## **Great North Road Solar and Biodiversity Park**

Draft Statement of Common Ground with National Highways

Document Reference – EN010162/APP/8.4C

Revision number 4

Project:  
**AADT CONSTRUCTION TRAFFIC FLOWS ON A1  
 WORST CASE (100% Route North AND 100% Route South)**

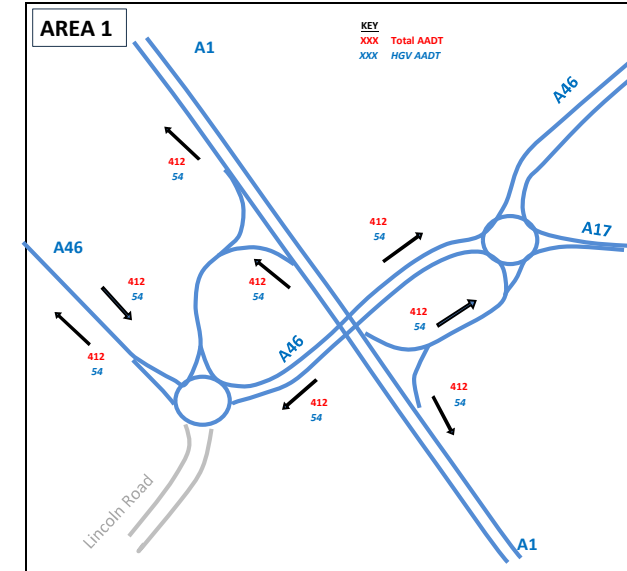
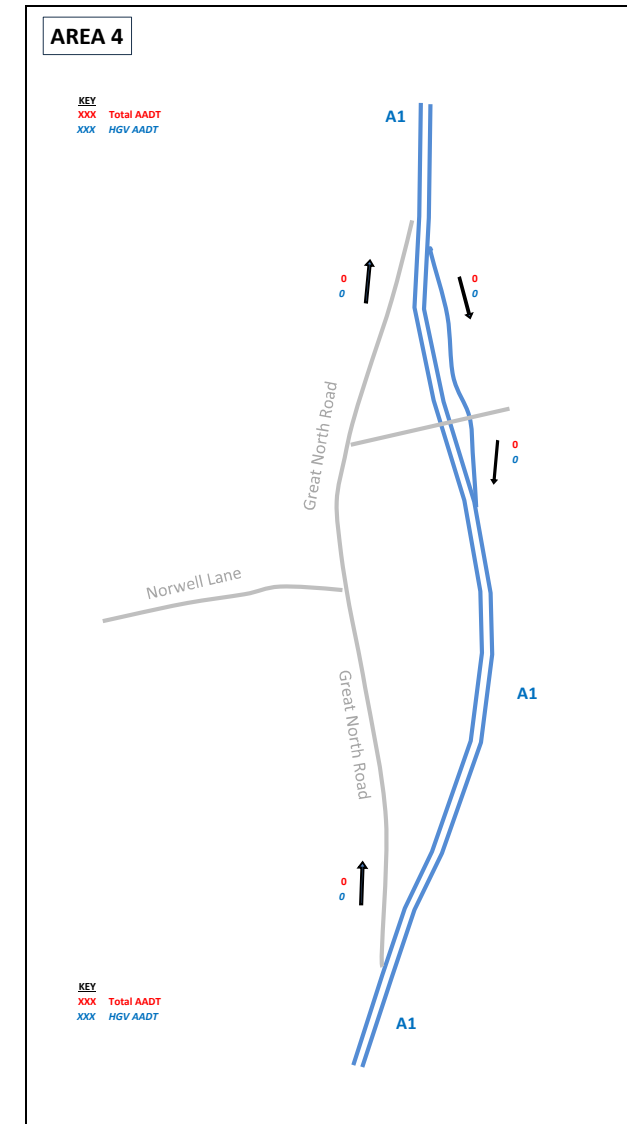
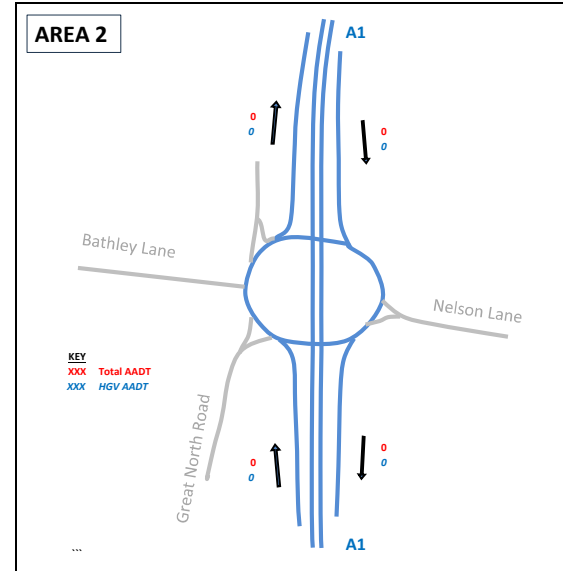
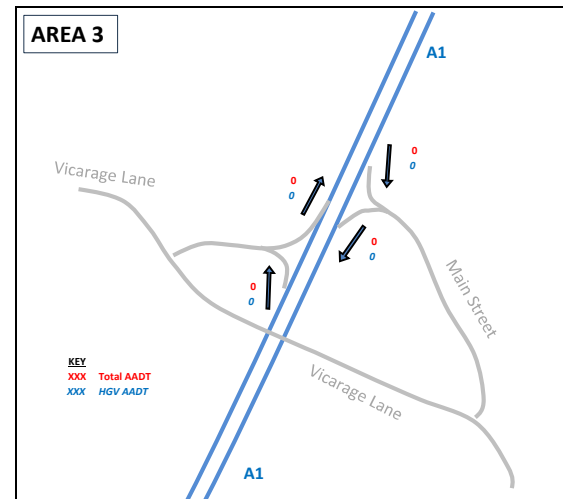
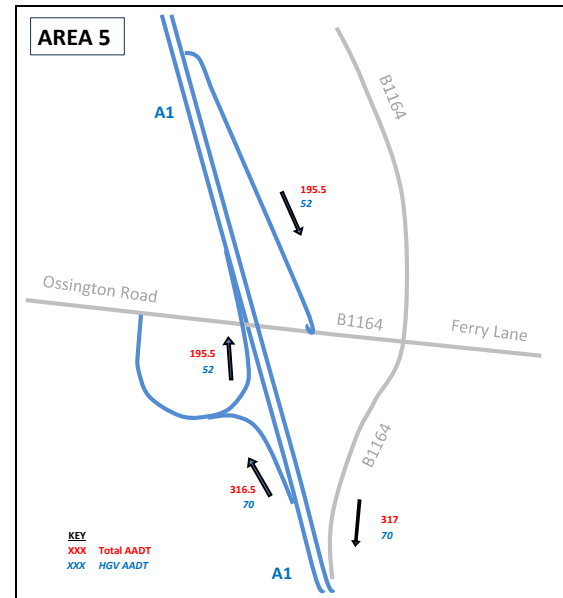
Month																						1	2	3	4	5	6	7	8	9	10	11	12	13	14	15	16	17	18	19	20	21	Trips on A1	0	12	20	26	6	10	10	11	11	11	7	4	1	16	28	36	8	12	13	13	13	
	Month																																																																						
	1	2	3	4	5	6	7	8	9	10	11	12	13	14	15	16	17	18	19	20	21																																																		
Trips on A1	0	12	20	26	6	10	10	11	11	11	7	4	1	16	28	36	8	12	13	13	13																																																		
2.1.5	WR	Trip Distribution	NH has reviewed the further information provided by the Applicant and is now content that the trip distribution is agreed. The additional information provided in the revised ES Chapter alongside the traffic flow diagrams	Traffic flow diagrams for the junctions on the A1 were provided at Deadline 1. The flows presented are the AADT construction traffic flows on the A1, assuming a scenario whereby all traffic routes to/from the north and also, all traffic routes to/from the south. These diagrams	Agreed

provided at Deadline 1 provides clarity on the development proposals impact on the A1 and are deemed acceptable by NH.	will show the traffic flows currently presented in Appendix 1 of this SoCG.
